MCB Issue List for APR1400 Section 5.4.2.1

Figure-1. Before and After Installation of Eggcrate Flow Distribution Plate

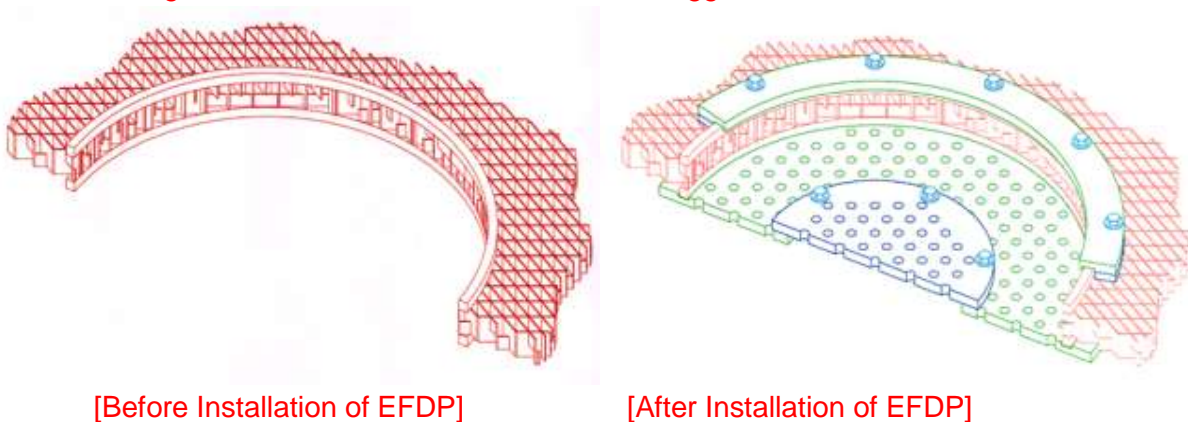
The discussion of tube supports in FSAR Subsection 5.4.2.1.2.2 states that this design has been proven to reduce wear in operating reactors.

Revise FSAR Subsection 5.4.2.1.2.2 to provide additional justification for the assertion. If it is based on operating experience outside the United States, provide information on this foreign operating experience to facilitate the staff's review.

Eggcrate flow distribution plate (EFDP) has been adopted to mitigate the concentrated flow into the central cavity region so as to reduce the localized wear. Up until Han-bit NPP Units 5&6 (OPR1000), there had been no EFDP. Han-ul NPP Units 5&6 (OPR1000) is the first of a kind steam generator to be equipped with the EFDP.

Figure-1 shows the schematics before and after the installation of EFDP.

Comparison of tube wear status at U-bend region between those NPPs provides an additional justification how the EFDP design reduces the tube wear at the central cavity region effectively. Tables 1 & 2 summarize the tube wear status (number of indications and number of tubes with indications) at U-bend region of Han-bit Units 5&6 and Han-ul Units 5&6 based on the recent eddy current test (ECT) results performed during their 6th in-service inspection (ISI).

For the APR1400 steam generator, thermal-hydraulic analysis had been performed to investigate the optimum number of EFDPs to be installed. Figure-2 presents the axial mass flux at the central cavity region according to the number of EFDPs for OPR1000 and APR1400 steam generators. There is no such benefit to have two or more EFDPs. Thus, there is one EFDP at the uppermost full eggcrate for APR1400 steam generator.

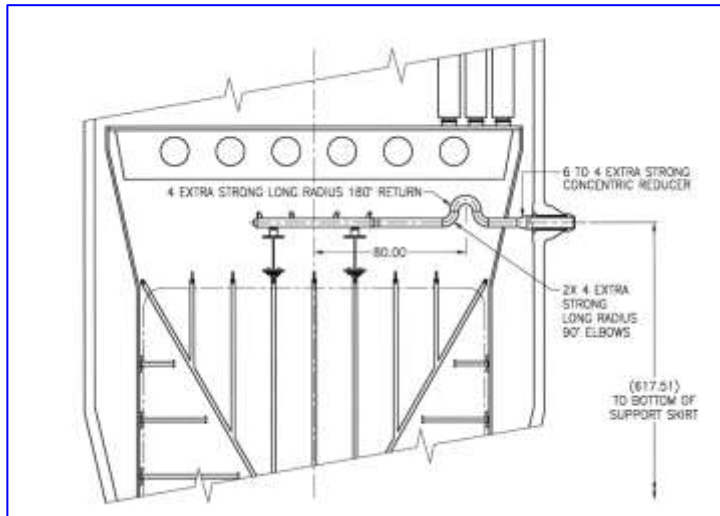
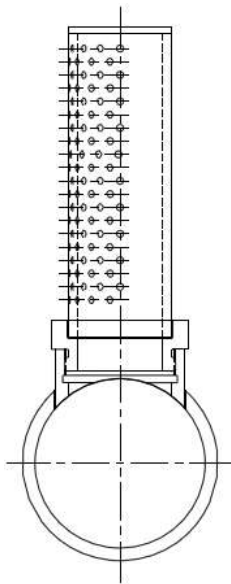
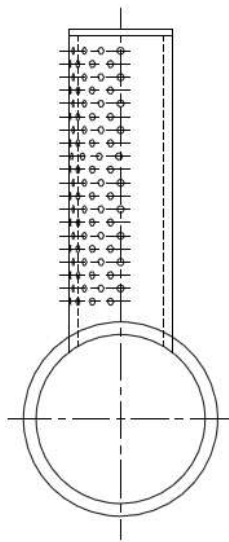
Revise FSAR Subsection 5.4.2.1.6 to explain the difference between downcomer feedwater and recirculation feedwater rings, and provide the location of the feedwater box.

The downcomer feedwater ring inside the steam generator applies the upward bend using a goose-neck design and I-type spray nozzles having small holes (hole diameter is 0.23 inch) and are installed to prevent the foreign object inclusion. Two I-type spray nozzles at each end of the piping is threaded into the piping, thus the two I-type spray nozzles can be detached from the piping to remove any foreign objects.

The recirculation feedwater ring provides the circulation of water through the steam generator during wet lay-up and the addition of chemical cleaning agents. There are J-type discharge nozzles on the recirculation piping.

ELEVATION

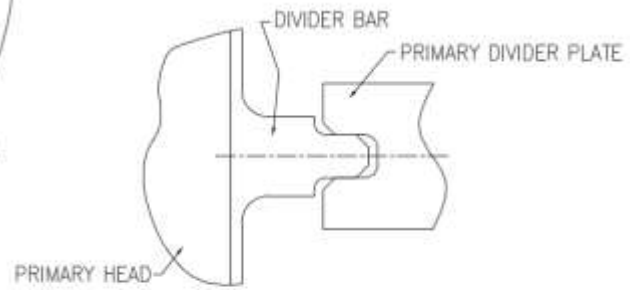
FSAR Table 5.4.2-2 identifies SA240, Type 410S martensitic stainless steel as the divider plate material for the steam generators. If the divider plate provides structural support to pressure boundary components (e.g., tubesheet), then the FSAR needs to provide the fabrication and processing requirements.

If the divider plate provides structural support, revise FSAR Table 5.4.2-2 to include fabrication and processing requirements for SA240, Type 410S martensitic stainless steel, or include a reference to a section in which such requirements are addressed.

The divider plate in the steam generator primary head applies the tongue-and-groove joint instead of welding to the primary head and tubesheet as shown below. The divider plate is not the structural support to the pressure boundary components.
